**Applicant 6-22-2021 Responses to
06-21-21 Council Questions.docx
101 Erwin Road – Conditional Rezoning Request**

- **Questions to Applicant from Council in Bold Blue**– Applicant Responses in Black.
- **Visual Exhibits referred to in this response are attached to this document.** Their location in the applicant’s full presentation is identified in these responses.

Stormwater Discharge Flow - Option For Study

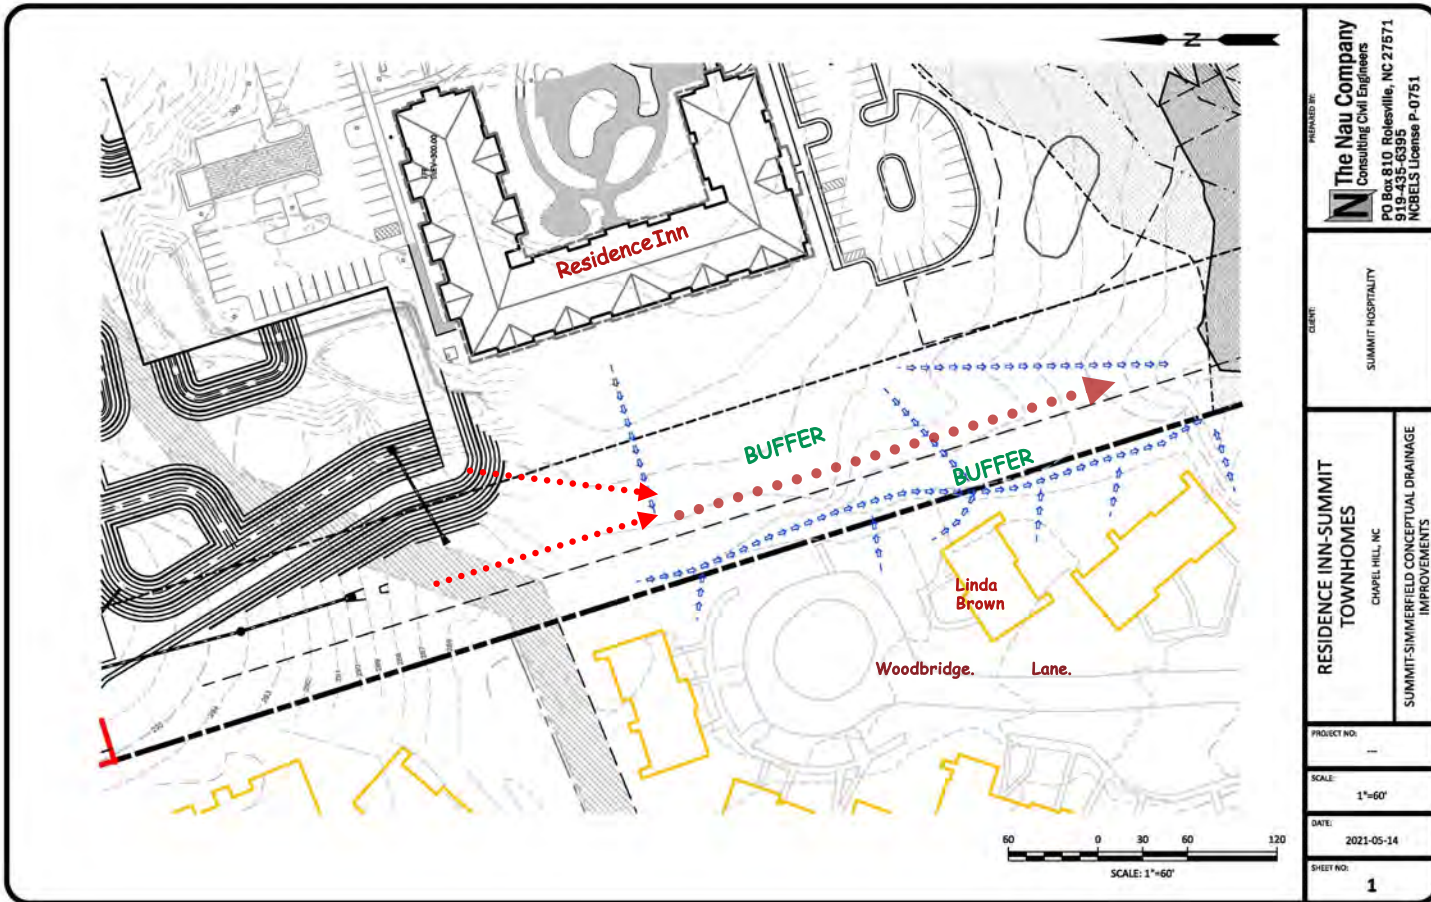
- iii) Linda Brown and the ten townhome owners at 104 – 118 receive stormwater flows from both Summerfield property and hotel property. A potential solution to this condition would be the creation of a surface channel on the applicant's property that would direct some stormwater flow from Analysis Point #2 and some from the rear of the hotel to a point where it is released near the southwestern portion of the hotel property.

This solution would require working in the current 100 feet buffer area.

① NORTH/SOUTH SECTION AT SUMMIT PLACE TOWNHOMES
SCALE: 1" = 20'-0"

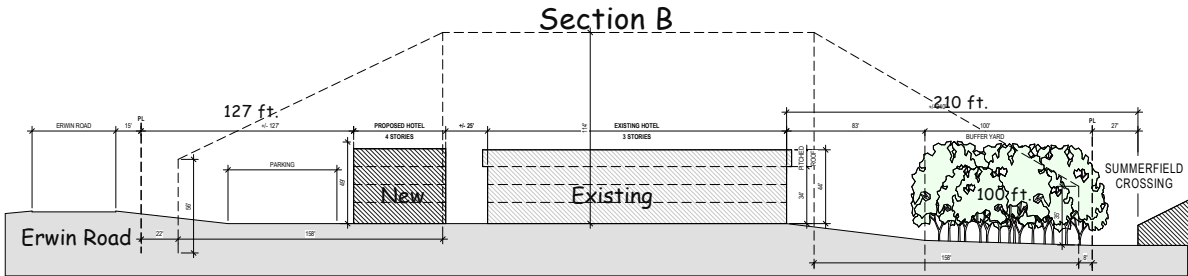
The images in this document are Exhibits #27 & #38 of the applicant's presentation. These show cross sections for both the hotel and townhomes showing the relationships to Summerfield Crossing, the nearest single-family home on E. Old Oxford Road and Erwin Road.

- a) Cross Sections – show building heights and bulk forms and distances with tree buffers as they already exist.
- b) Preliminary Townhome Elevations – All 10 buildings will be flat roof buildings with parapets shielding rooftop utility installations from view and are in the style of brownstone townhomes with their front elevations facing each other, open space in the development or Erwin Road. The illustrations showing the preliminary design show the townhome face that will front on Erwin Road.
- c) Preliminary Hotel Elevations - The hotel will continue the existing architectural style – adjusted slightly so that the flat roof of the proposed new building is virtually the same as the existing 3-story building.

AH Units are A1 Units First Floor Plan

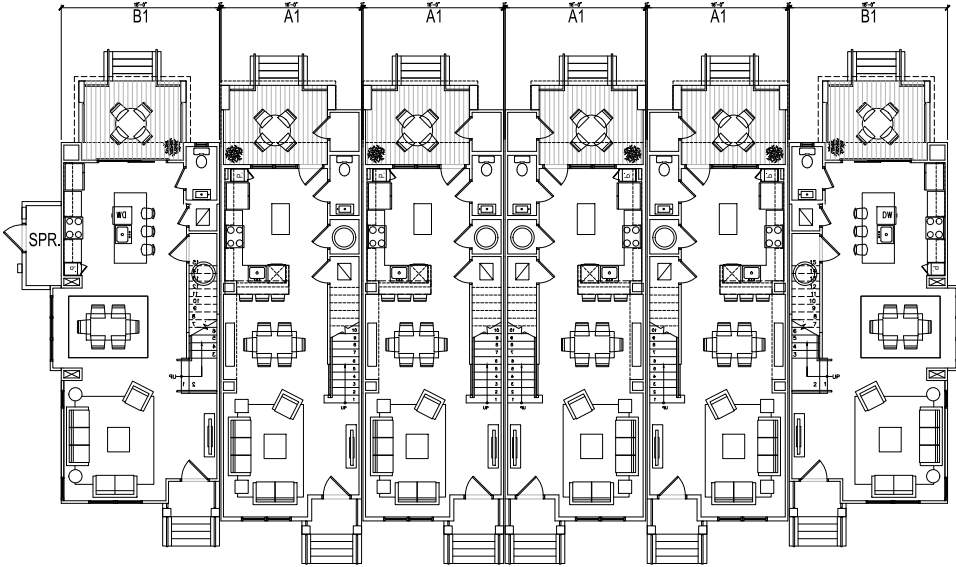
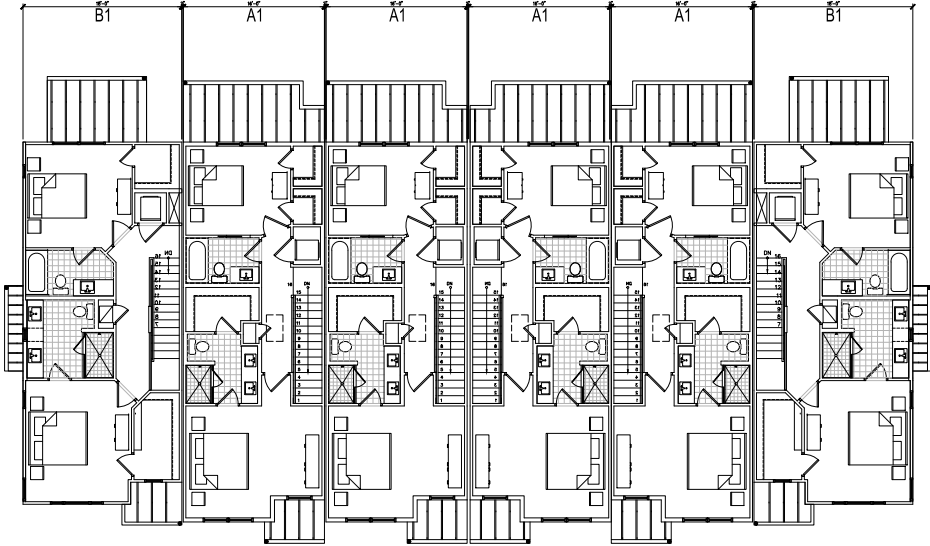
- d) **Council Member Question - Is it possible to have the affordable units have 3BR units in the same proportion as market rate townhomes? - That would be 5@2BR and 2 @3BR.**

- i) The proposal is for 2BR townhomes and was arrived at after discussions with the Community Home Trust about what types of housing were in most demand, what types had the most flexibility to accommodate multiple family types and are townhomes of sufficient size that they will be easily adaptable to the 2nd, 3rd, and 4th owner families.

- ii) Townhomes with 2-BR, 2-Baths, and W/D on the second floor and a powder room on the first floor were designed at approximately 1,320 SF, double the minimum size in the LUMO for a 2-BR affordable housing unit. All exterior and interior finishes and are proposed to be the same for the affordable townhomes as the market rate townhomes. Our design focus was on livability over time.
